RESPONSE TO COMMENTS

June 25, 2025

**RE: SECOND SUBMISSION REVIEW: TRIBUTARY – MASTER PLAN WITH ADJUSTMENT
AND ZONING MAP AMENDMENTS**

TRIBUTARY | 2 MILE OFFSET FROM NEARBY COMMUNITY PARKS

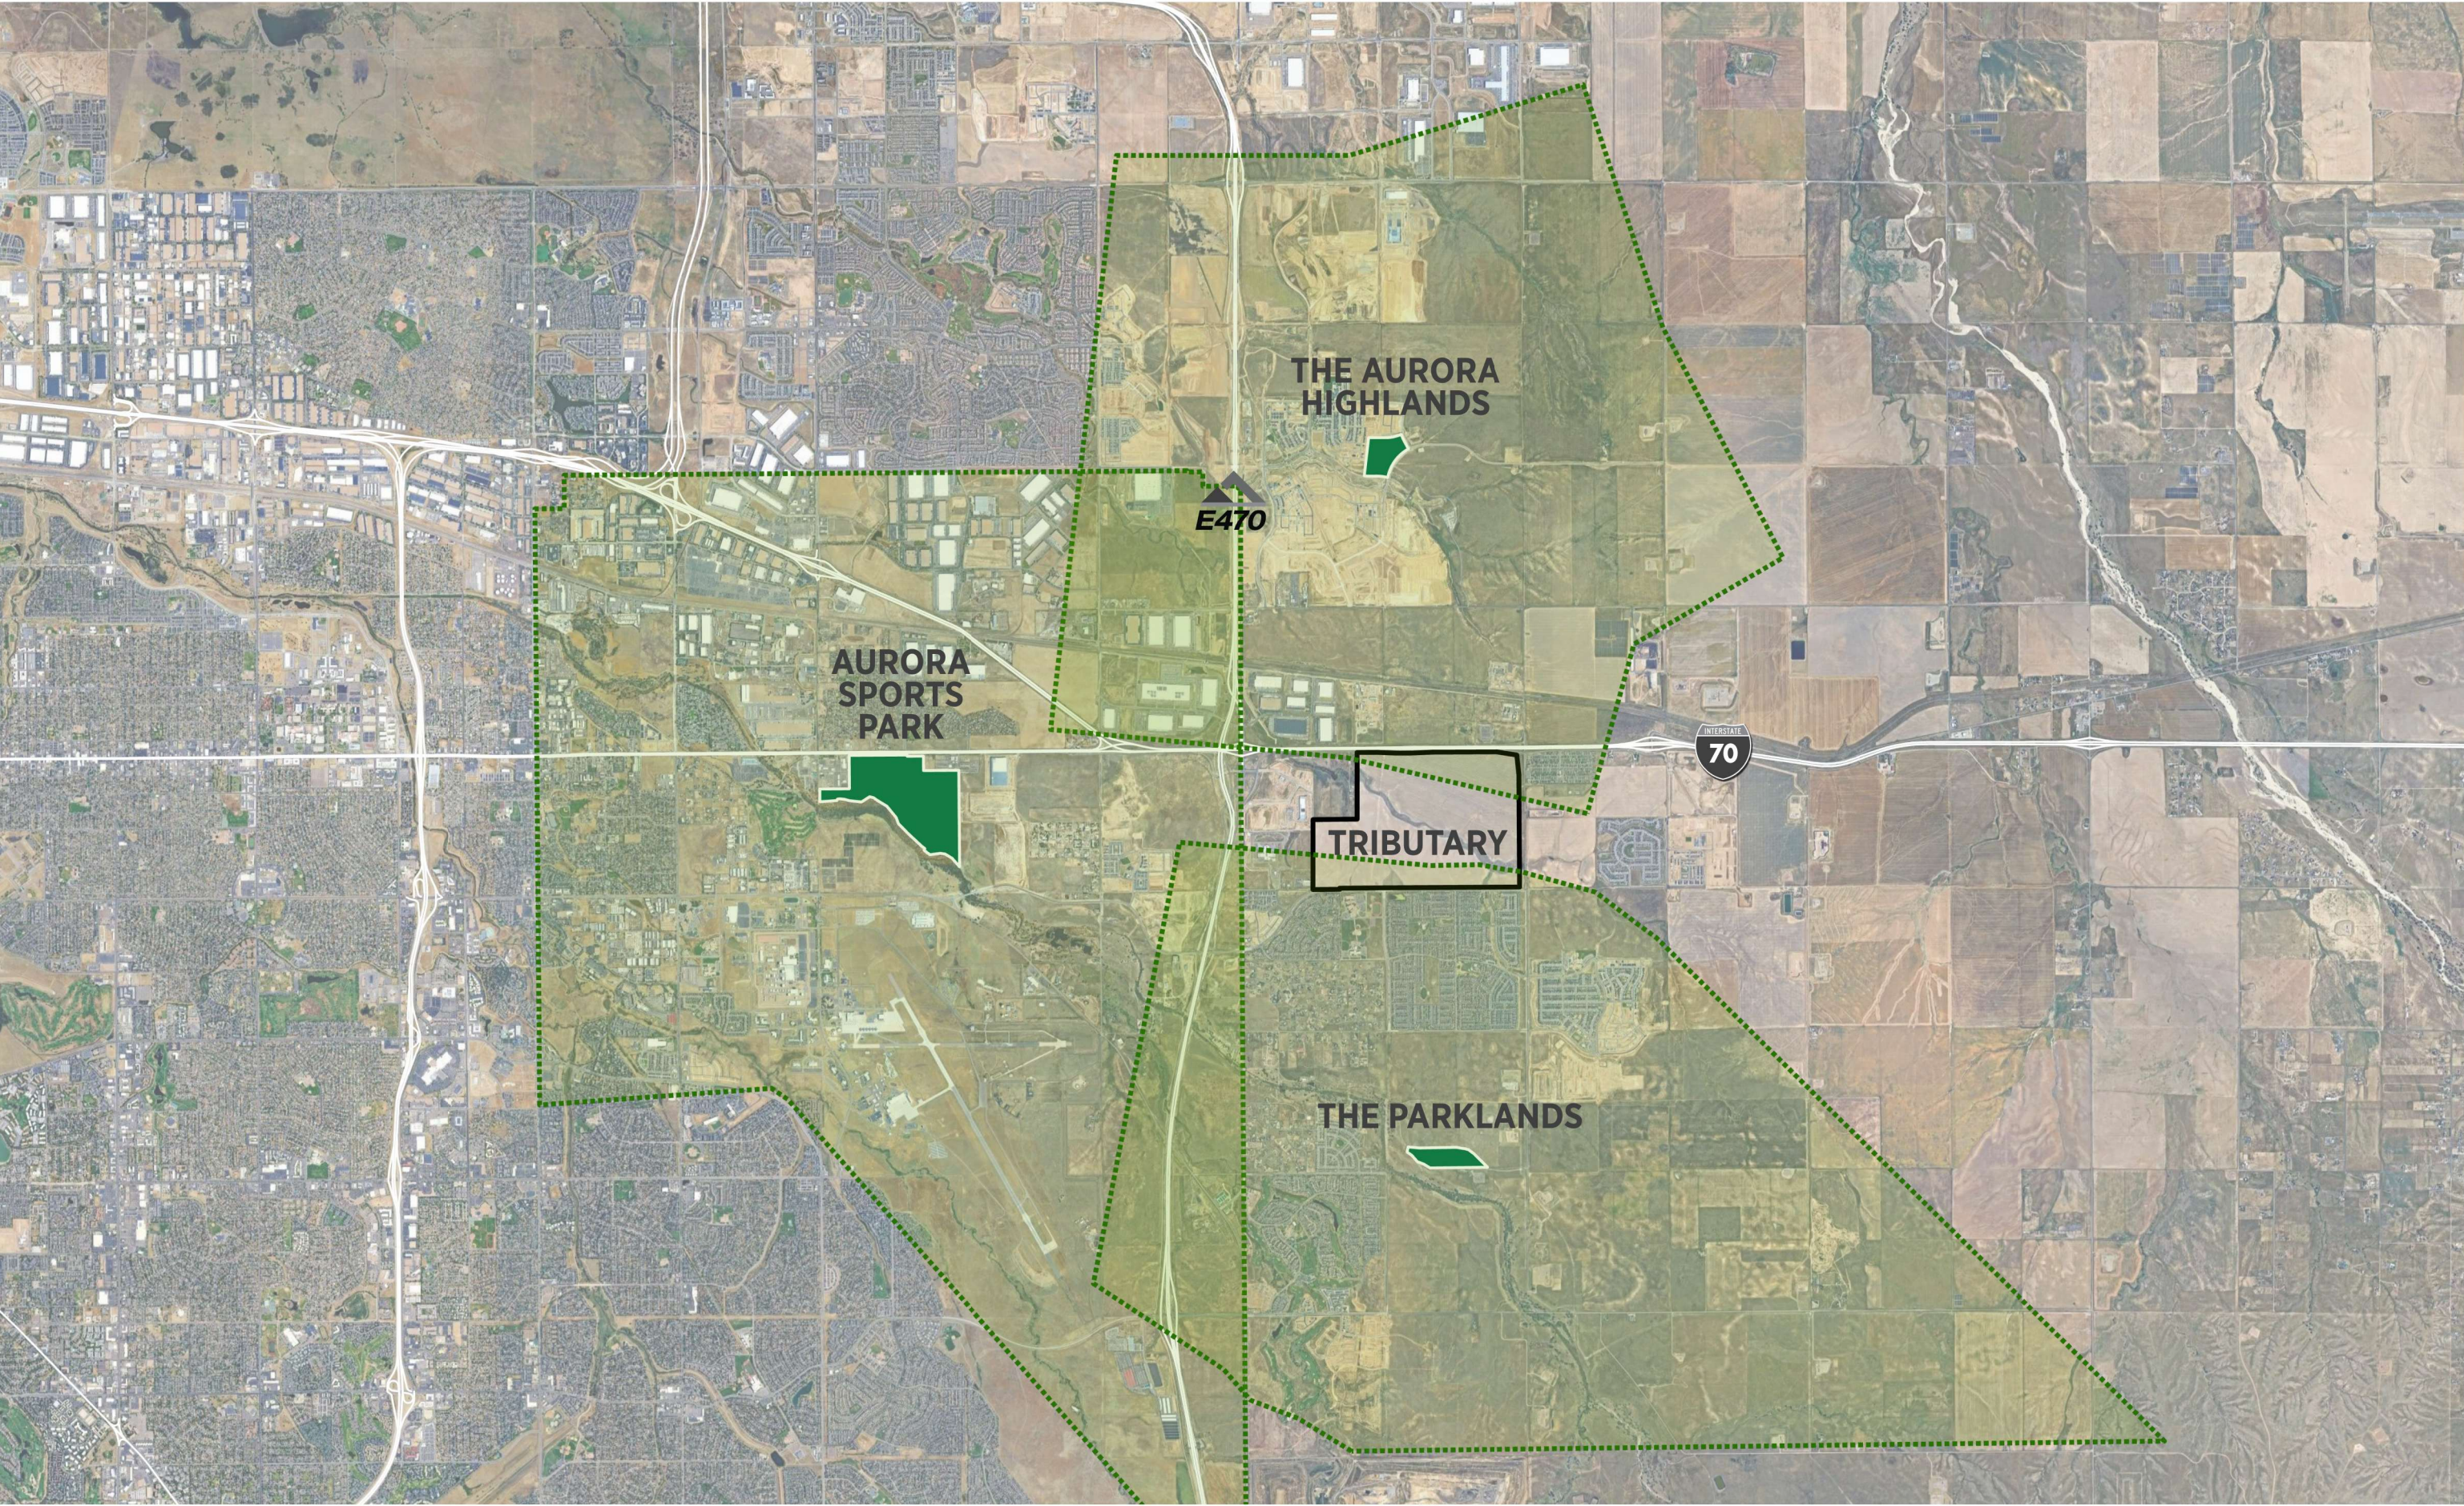
Response: Additional language has been added.
 - e. Community Park: In the notes, include the closest existing or planned community park for reference.
Response: A community park exhibit has been attached to these RTCs.
